**COMMITTEE OF ADJUSTMENT**

**NOTICE OF PUBLIC HEARING**  
**Minor Variance**

<b>APPLICATION NO.:</b>	<b>SC/A-19:328</b>	<b>SUBJECT PROPERTY:</b>	12 LAKESIDE DRIVE, STONEY CREEK
<b>ZONE:</b>	"R2" (Single Residential)	<b>ZONING BY-LAW:</b>	Zoning By-law former City of Stoney Creek 3692-92, as Amended

**PURPOSE & EFFECT:**      To recognize additions to the existing single detached dwelling:

SITE PLAN  
SCALE 1:200

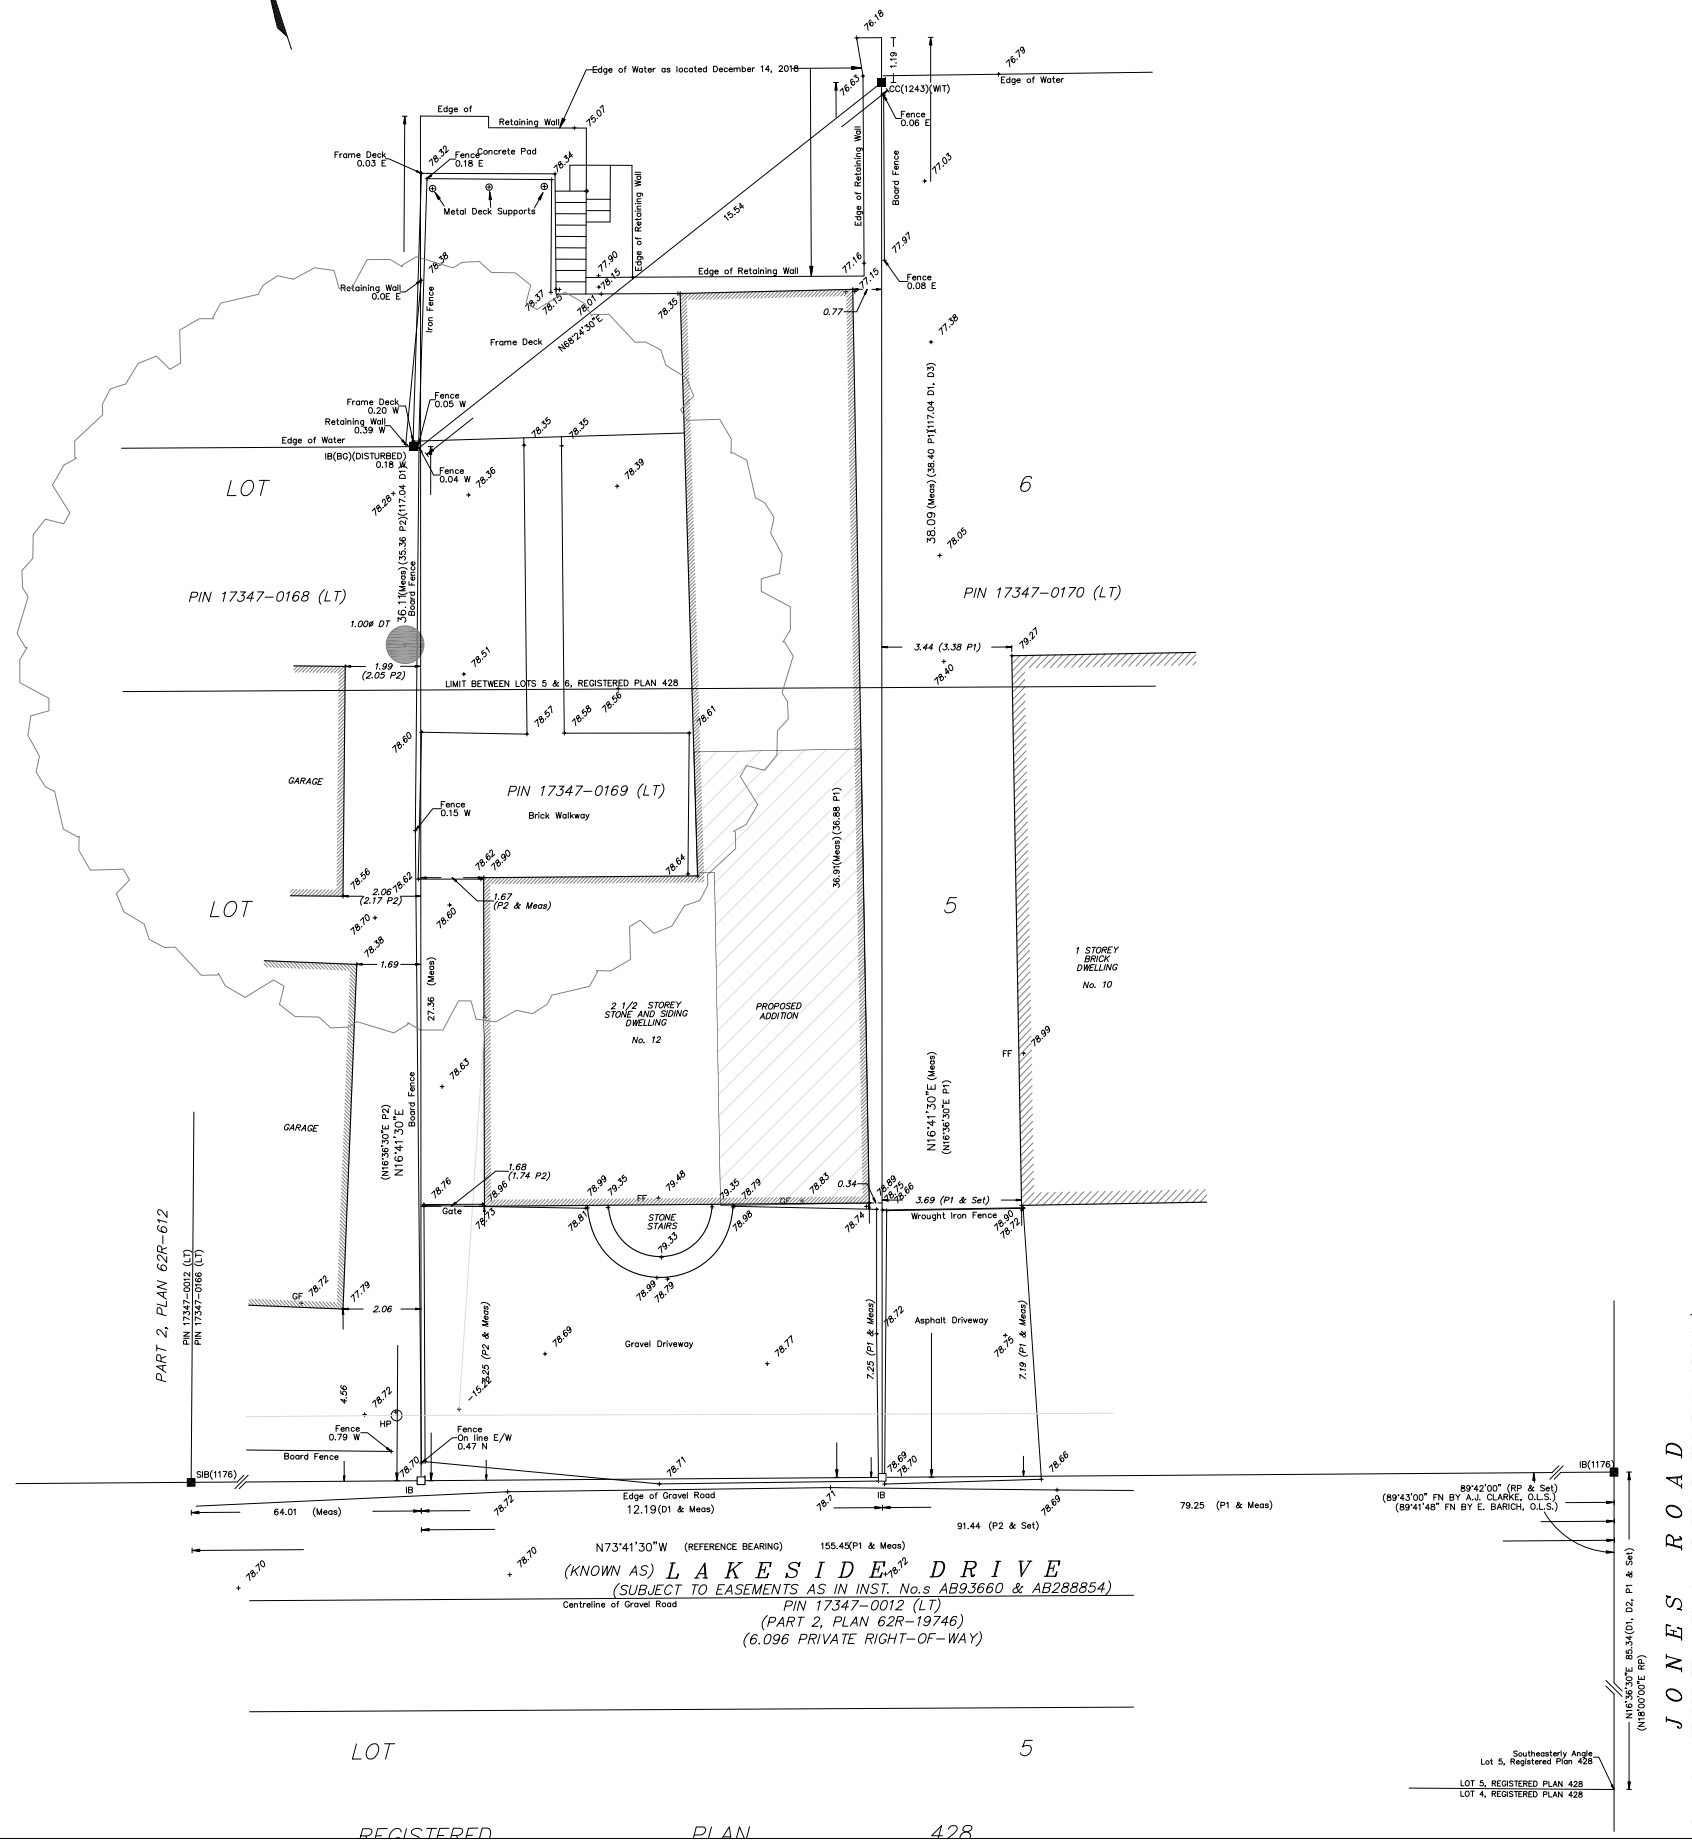
1. The dwelling shall be permitted to be located 0.34 m from the east side lot line instead of the minimum required east side yard setback of 1.25 m;
2. The dwelling shall be permitted to be located 0 m from the rear lot line instead of the minimum required rear yard setback of 7.5 m;
3. The dwelling shall be permitted to be located 0 m from the top of bank of the Lake Ontario shoreline instead of the minimum required setback of 7.5 m;
4. The eaves and gutters of the dwelling shall be permitted to encroach the full width of the east side yard, up to the maximum 0.77 m, instead of the maximum encroachment of 0.5 m.; and
5. The dwelling shall be permitted a lot coverage of 44.3% of the lot area (173.79 sq m) instead of the maximum permitted lot coverage of 40% (156.84 sq m).

- ii. With respect to Variance 1, concerning the east side yard setback, the required setback has been identified as 1.25 m, contrary to the application submission noting 1 m, since the east side addition includes building portions other than an attached garage, which require relief from the minimum setback of 1.25 m;

- iii. With respect to Variances 2 and 3, concerning rear yard setback and top of bank setback respectively, since the site plan does not clearly identify the rear lot line or top of bank, and does not include a dimension from either limit to the nearest portion of the dwelling, a variance for 0 m setback has been identified for each required setback. The applicant may provide a revised site plan clearly identifying these limits and setbacks to clarify the relief required. If clarifying top of bank, please include confirmation from the Hamilton Conservation Authority regarding its location;

- iv. With respect to Variance 4, concerning eave projection, relief for encroaching the full east side yard has been identified since the eave projection is not dimensioned in the plans and gutters are not shown. If the eaves and gutters project no more than 0.5 m from the east side wall of the dwelling, then this variance is not required. Please note that a variance from the Zoning By-law does not constitute permission for an eave or gutter to encroach into adjacent private property. Any encroachment into private property may require a private encroachment agreement; and

- v. With respect to Variance 5, concerning lot coverage, this variance has been written as submitted in the original application. However, the figures are not reflective of the figures and percentages for lot area and lot coverage in the plans submitted. The plans note a coverage of 38.5% of the lot area. As such, this variance may not be required.
